In the Matter of  
ADVANCED MEDICAL SYSTEMS, INC.  
Material License No. 34-19089-01  
Docket No. 30-16055-ML-REN

24. Letter to John Madera, Chief - Nuclear Materials Licensing Section, U.S. Nuclear Regulatory Commission, Region III from David Cesar, Treasurer, Advanced Medical Systems, re: response to letter dated April 17, 1995 requesting additional information for renewal of license, June 16, 1995.

In response to your letter dated April 17, 1995 in which you request additional information for renewal of License No. 34-19089-01, the following are our responses:

## Cumulative Sanitary Sewer Release Activity vs. Year

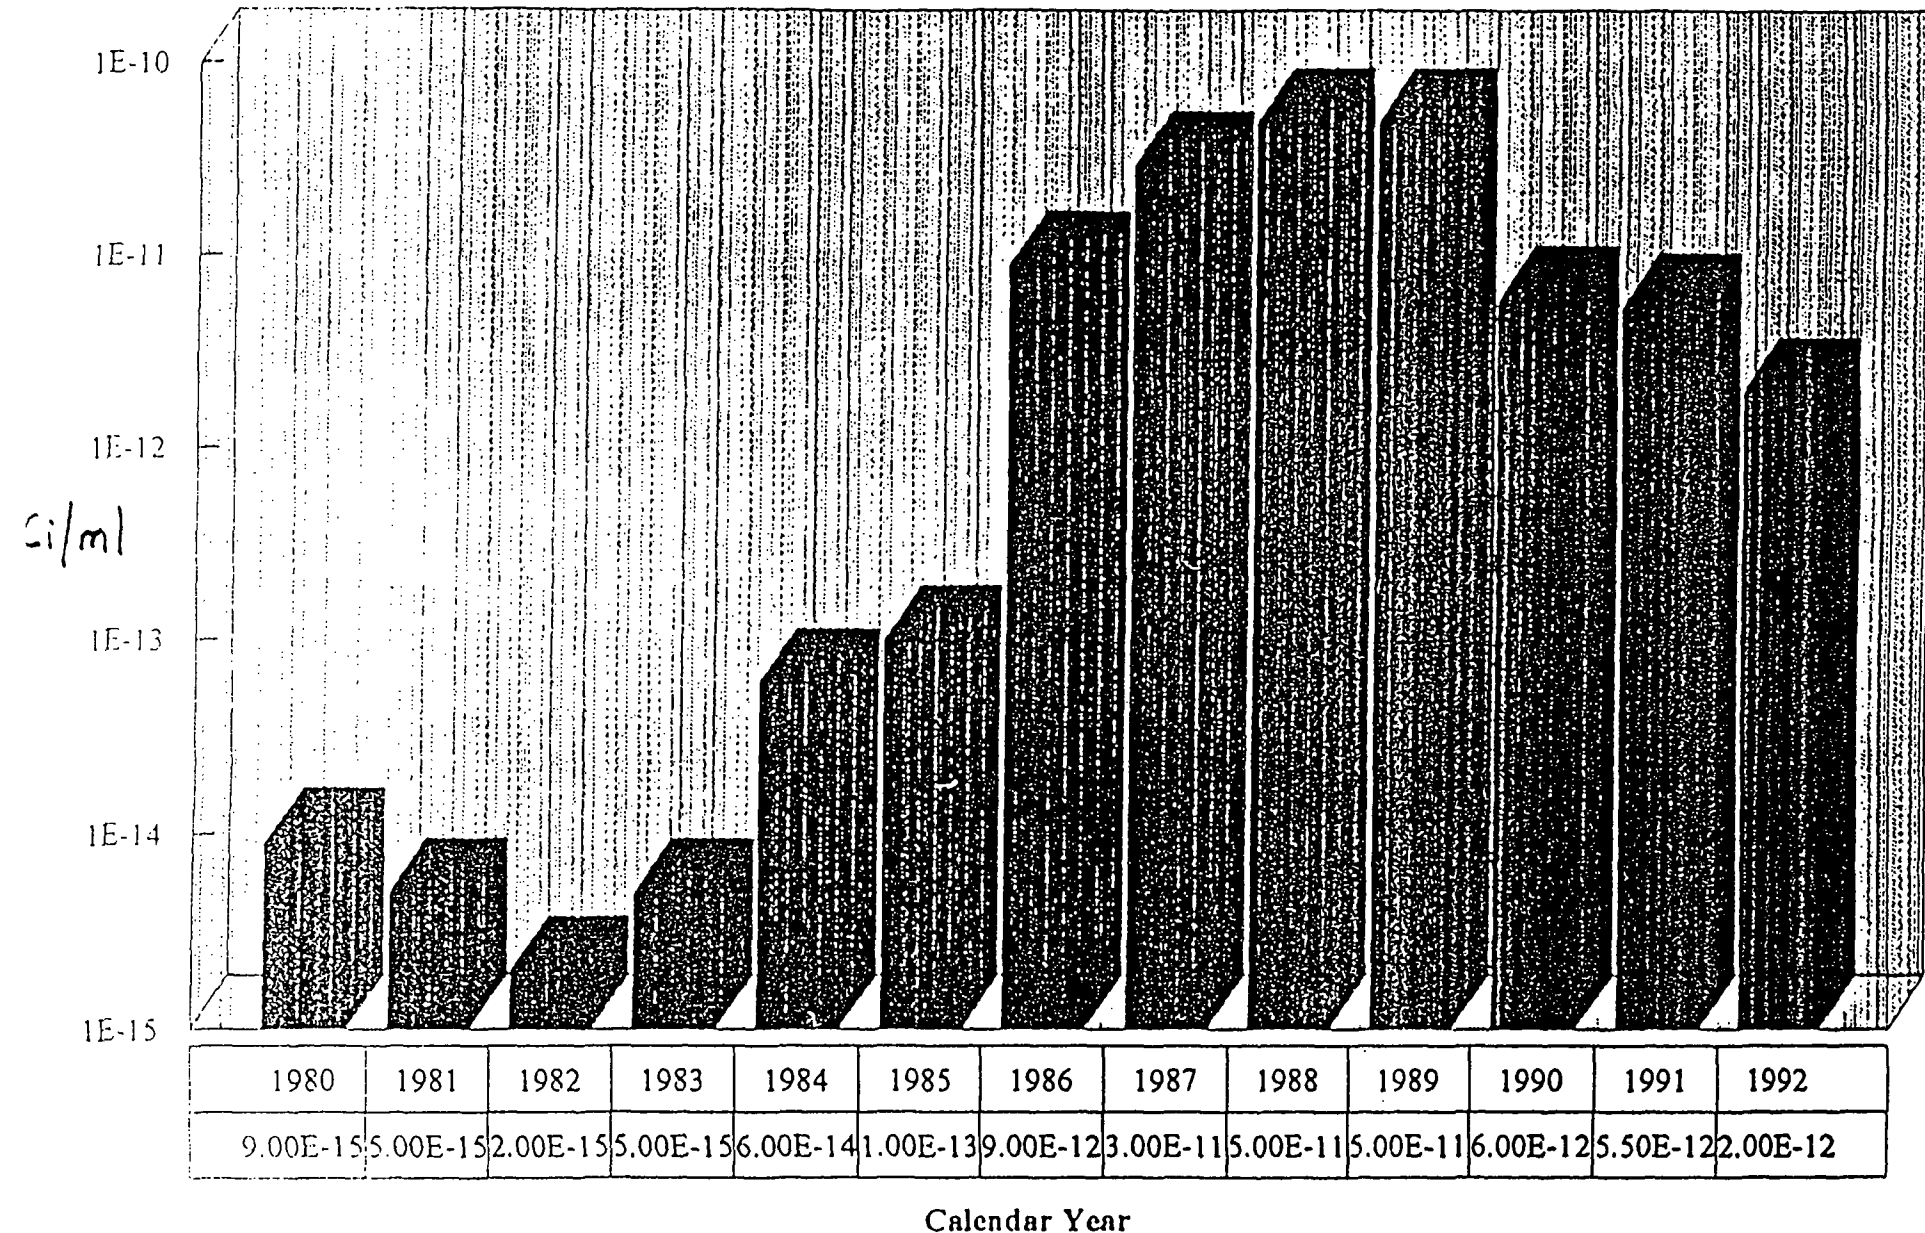
should be  
35.6 mCi
